**LEBANON MINOR SITE PLAN REVIEW
COMMITTEE
THURSDAY, JULY 10, 2025 - 1:00 PM
COUNCIL CHAMBERS, CITY HALL OR
REMOTE VIA VIRTUAL PLATFORM
LEBANONNH.GOV/LIVE**

TO: Lebanon Minor Site Plan Review Committee
FROM: Planning and Development Department Staff
RE: 16 Parkhurst Street, Tax Map 92 Lot 61
DATE: July 1, 2025
APPLICATION: Continuation of PB2025-35-MSP

TO: Lebanon Minor Site Plan Review Committee
FROM: Planning and Development Department Staff
RE: 3 Campbell Street, Tax Map 92 Lot 65
DATE: July 1, 2025
APPLICATION: PB 2025-35-MSP

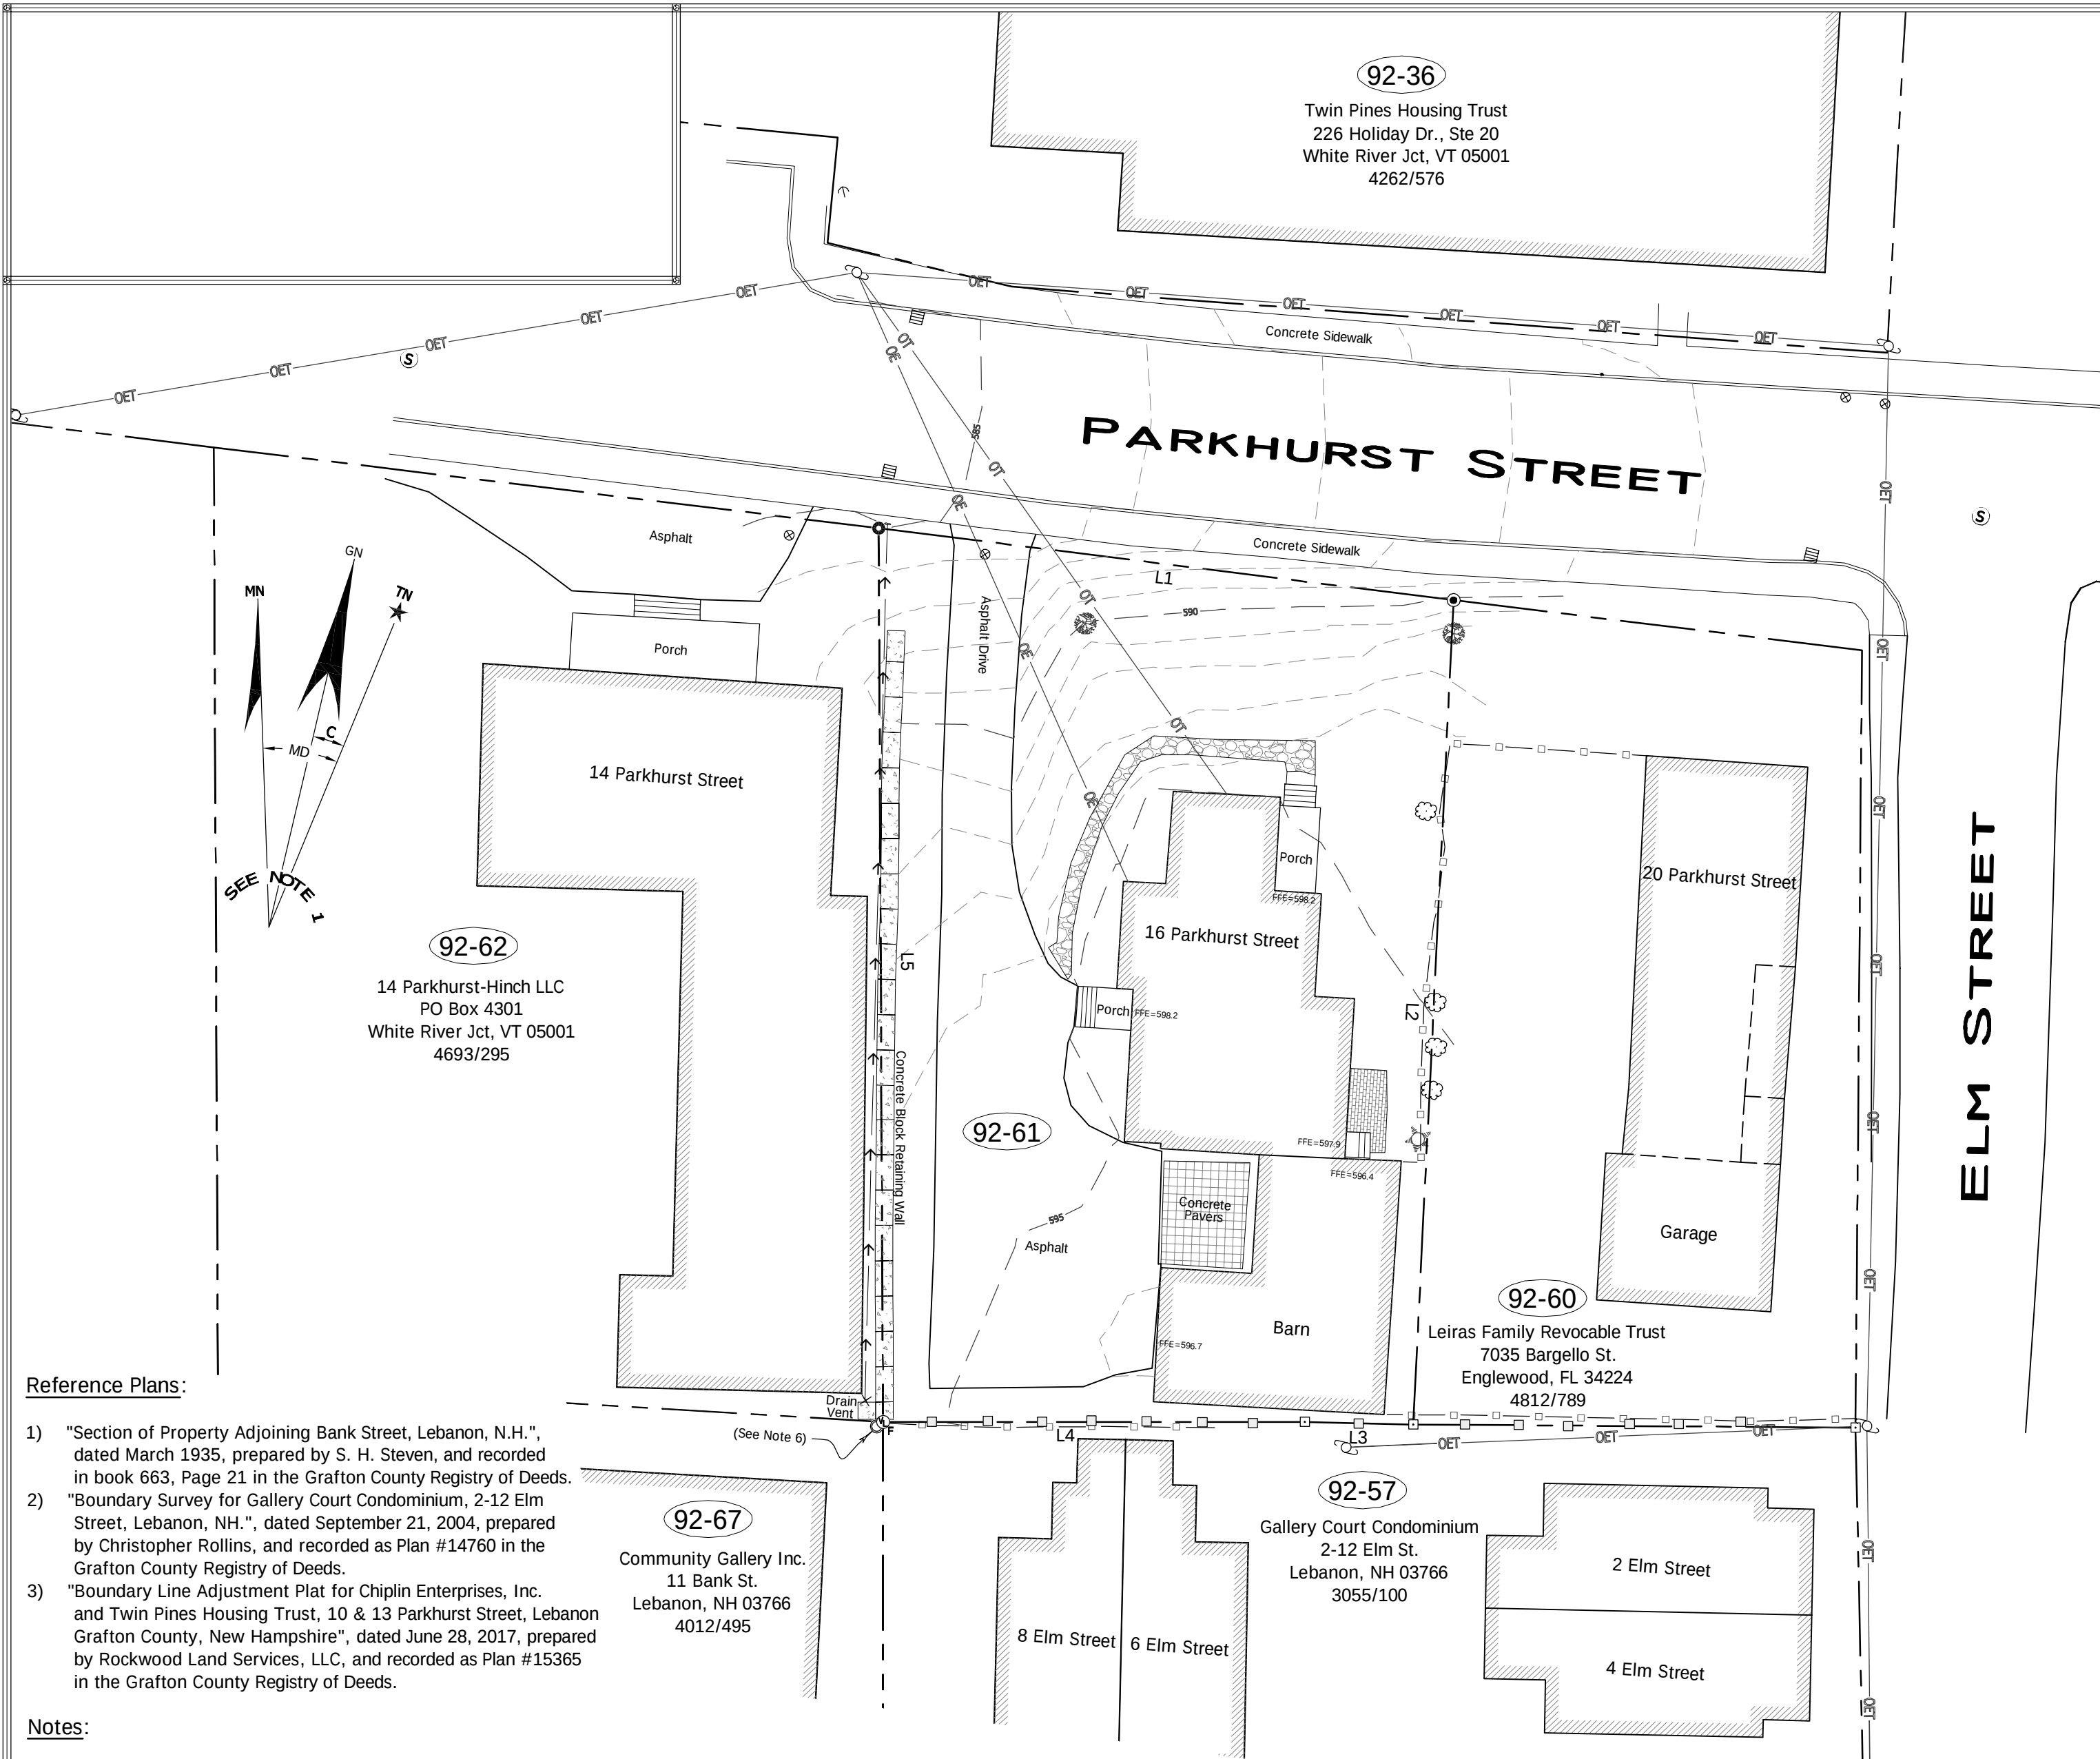
The Committee should be aware that the applicant submitted two parking plans. Staff believes there needs to be clarification on Site Plan B, the access isle for the accessible space is overlapped with the “barn” structure. EV parking was mentioned in the original application but is not noted in the updated site plans. This element of the site plan needs to be clarified.

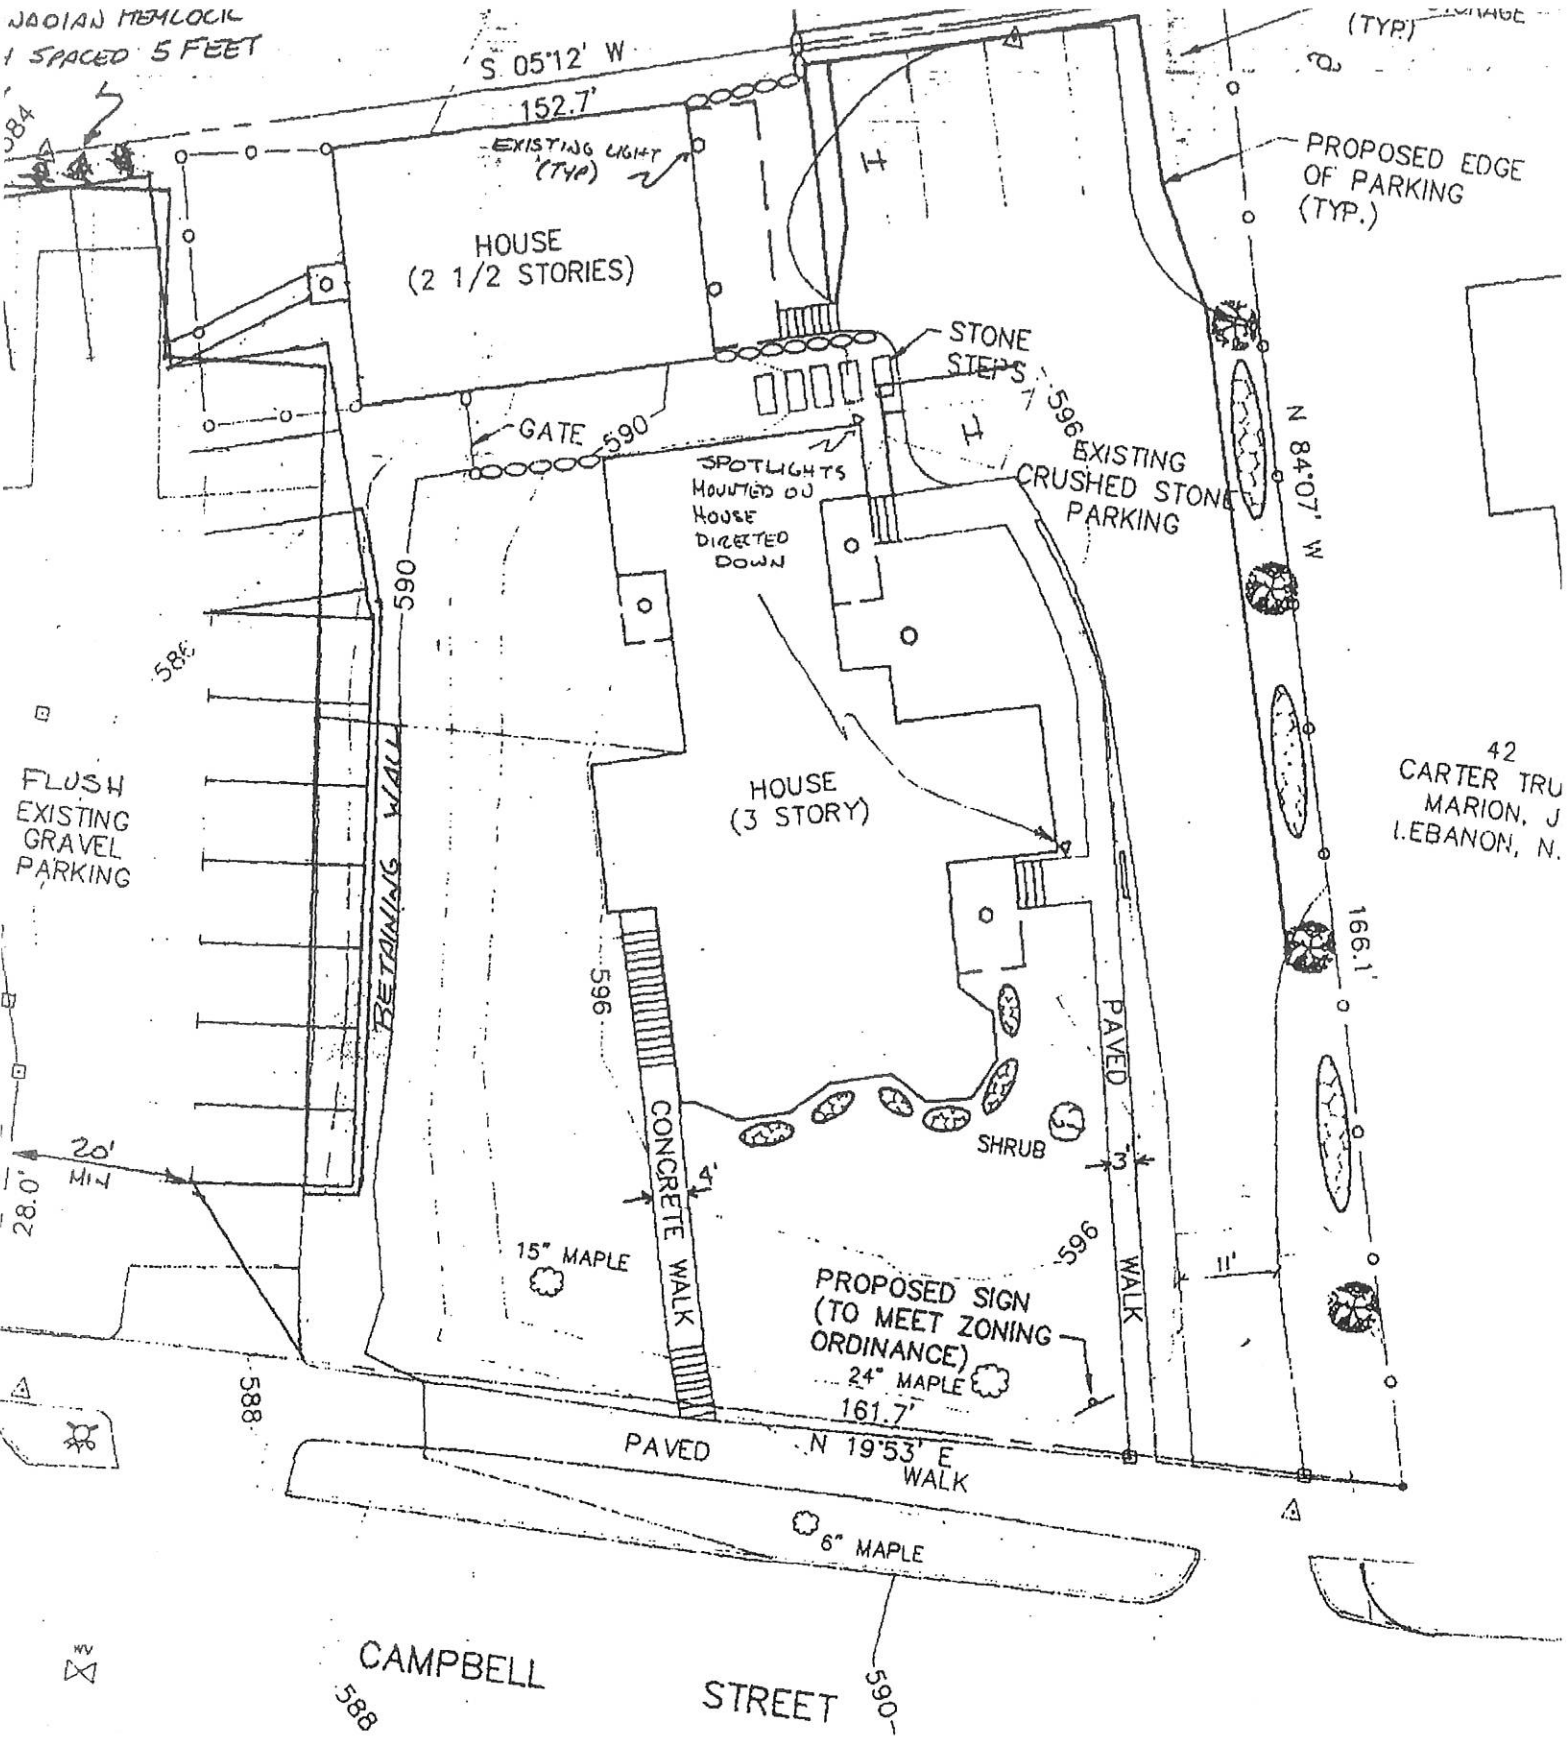
The applicant states that their landscaping plan was approved in 1992. The applicant is changing the use of part of the building from office to residential and with that would need to meet current landscape regulations. The site plan submitted does not show any new landscaping. The applicant would need a waiver from this section.

The applicant shows 3 existing lights on the submitted site plan. No new changes to lighting were noted. The walkway to the north is unlit and its unclear what the lighting is for the 13 parking spaces on that same side. Streetlights are also a feature on Campbell Street that would illuminate the front portion of the property. Staff asks for Police to provide their input.
